CLAREMONT BUSINESS PARK 2 FIL. NO. 2  
CONSTRUCTION NOTES, LEGEND & DETAILS  
PROJECT NO. 10-020  
DATE: 07/20/23  
SCALE: HORIZONTAL: N/A VERTICAL: N/A  
DESIGNED BY: GW  
DRAWN BY: CLP  
CHECKED BY: VAS  
SHEET 2 OF 14  
CD02

# V3\_Construction Drawings.pdf Markup Summary

**CDOT TYPE C WATER QUALITY OUTLET BOX AND SAND FILTER SECTION A-A NOT TO SCALE**

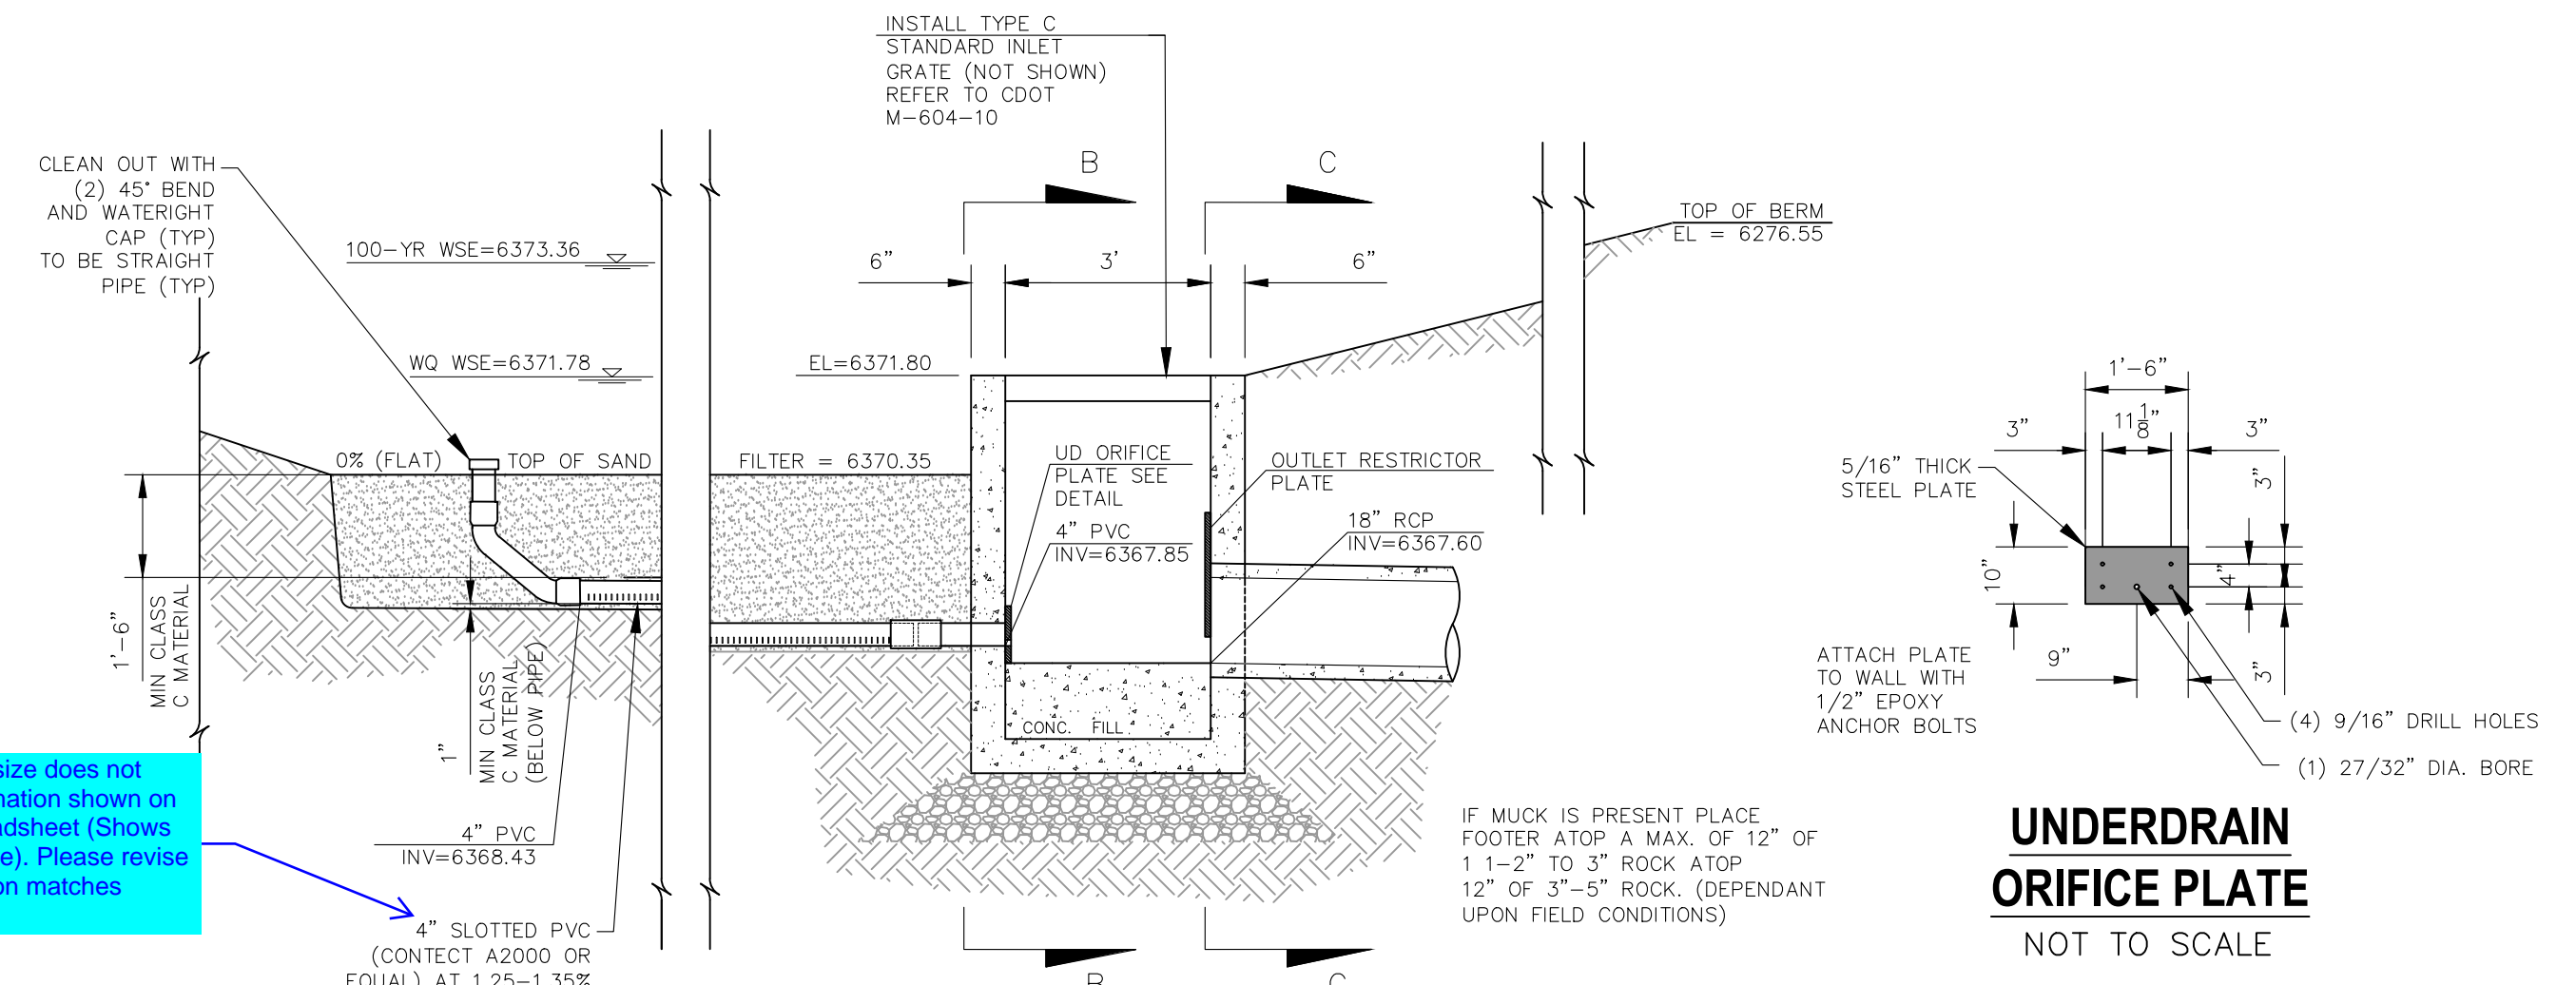
Underdrain size does not match information shown on MHFD spreadsheet (Shows 0.84" dia pipe). Please revise so information matches

PER TABLE SF-2 MINIMUM PIPE SIZE IS 4". SEE UNDER DRAIN ORIFICE PLATE (TO RIGHT). ORIFICE PLATE WILL DISCHARGE THROUGH 0.84" DIA HOLE. THE ORIFICE PLATE IS THE CONTROL, NOT THE 4" PIPE

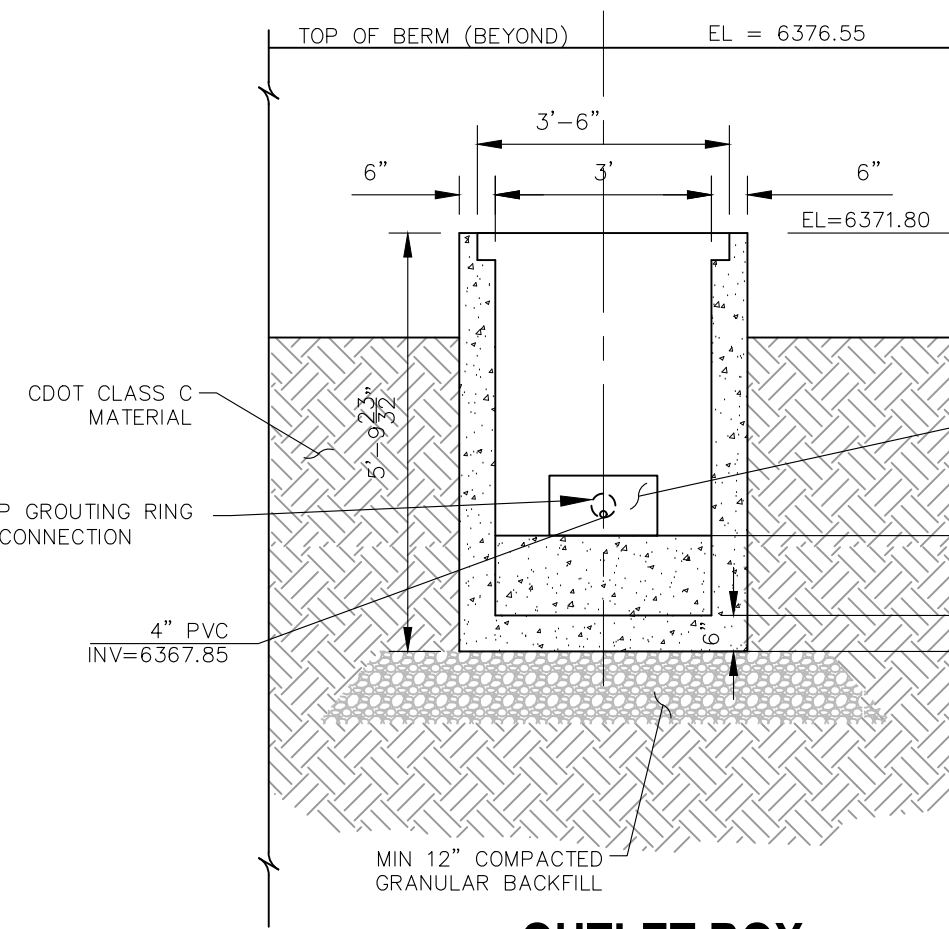
Unresolved: 100-YR WSE does not match other details or MHFD spreadsheet. Please update

100-YR WSE=6373.12  
ELEVATION REVISED TO 6373.36.

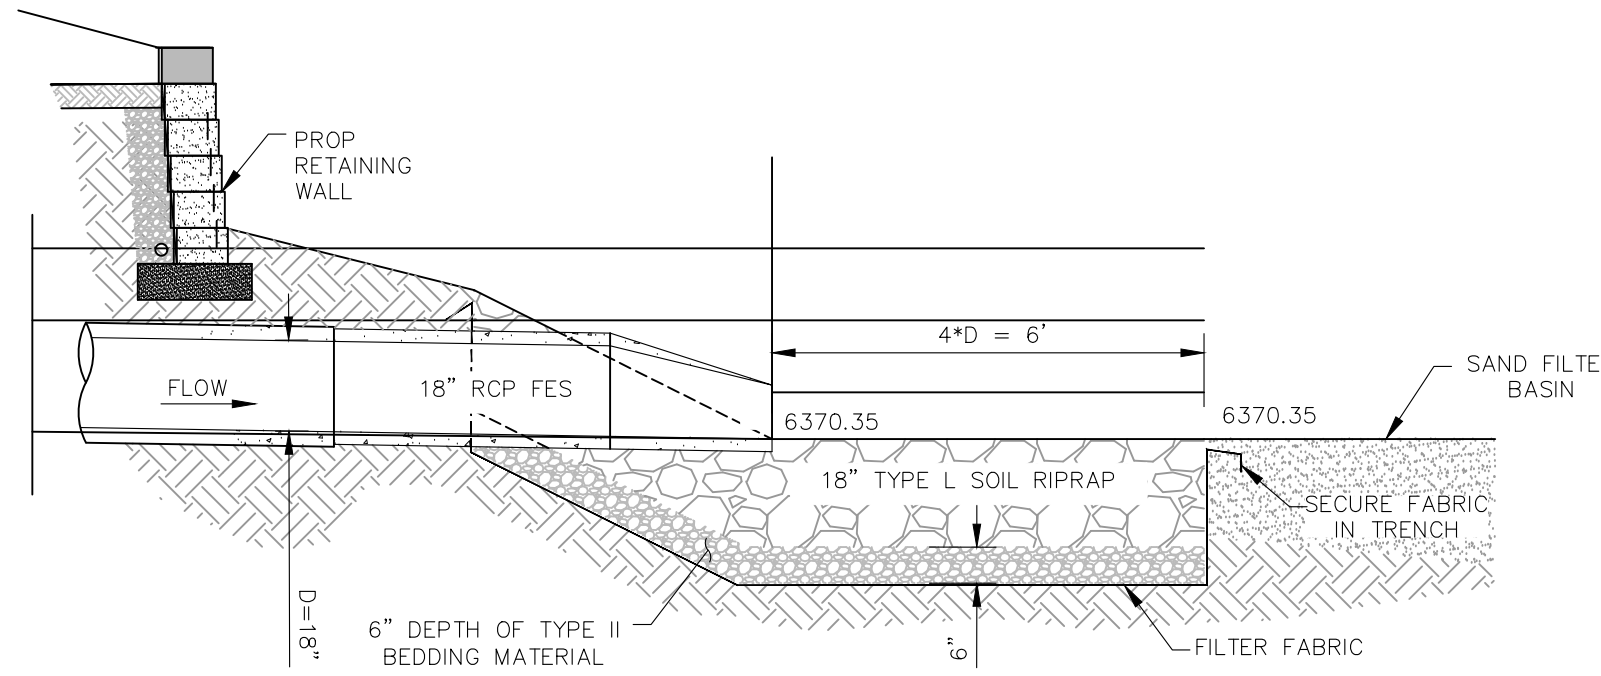
Revise to 6375.25 to match other details and MHFD spreadsheet

REVISED TO 6375.44.

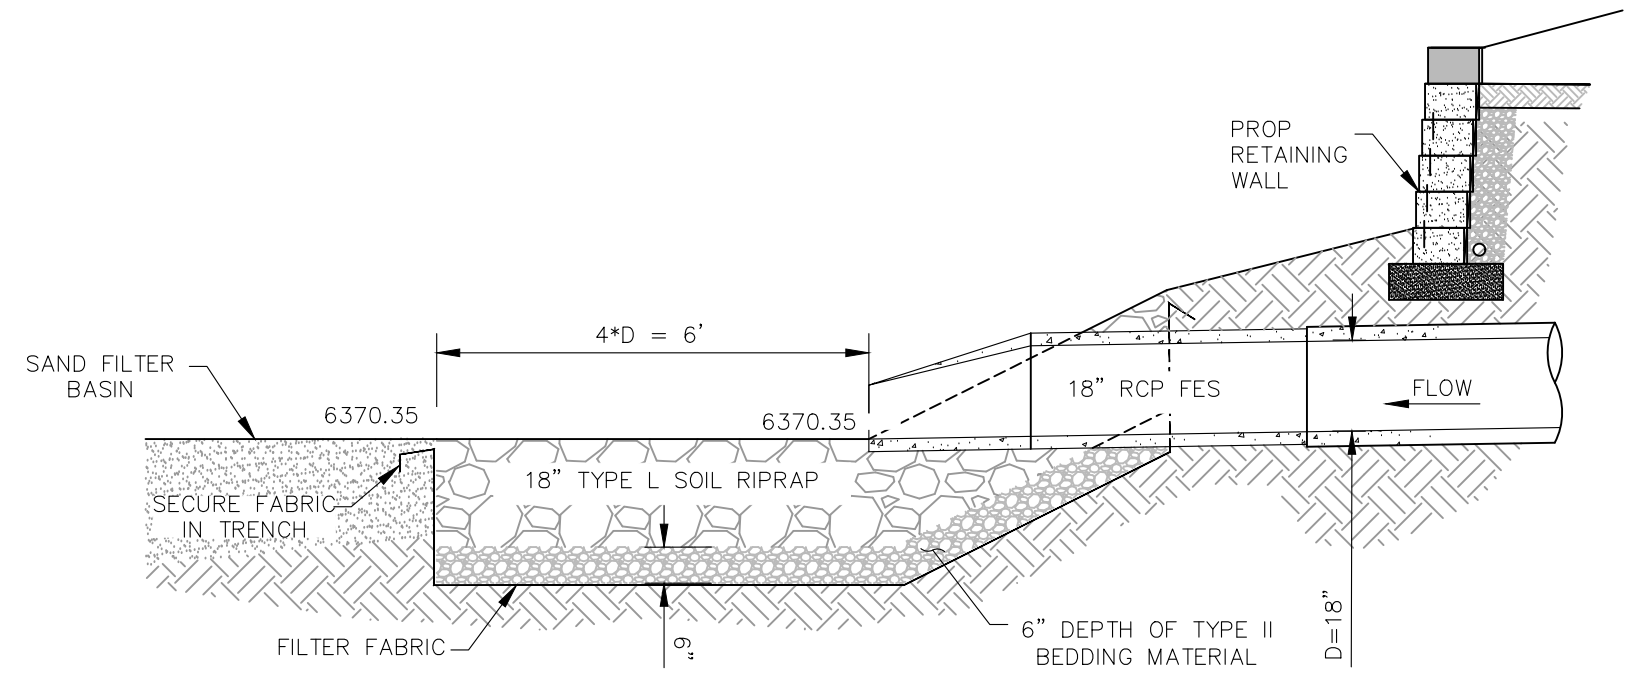
Revise to 6373.36 to match other details and MHFD spreadsheet

REVISED TO 6375.25.
